AC Charging Hardware and Cable Temperature

Vehicles Affected

Models	Model Year	Model Type	VIN Range	Vehicle-Specific Equipment
Taycan	As of 2020 up to 2022	Y1ADB1, Y1AFC1, Y1AFH1	All	73E, 73C

Figure 1

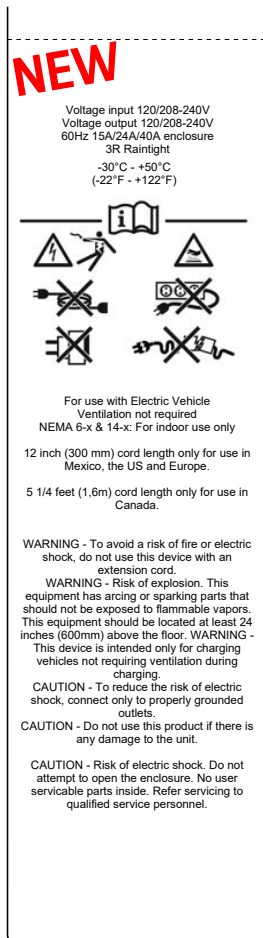
Errors may exist in the label affixed to supply cables provided with vehicles and cables produced through Calendar Year 2020.

Only one label variant exists and is affixed to all supply cables in USA and Canada (NEMA5-15, 6-/14-30, and 6-/14-50). Figure 1 shows the existing label with errors. Figure 2 shows the updated label.

Supply cables fitted with labels with errors are addressed with Workshop Campaigns WMP4 or WNM6.
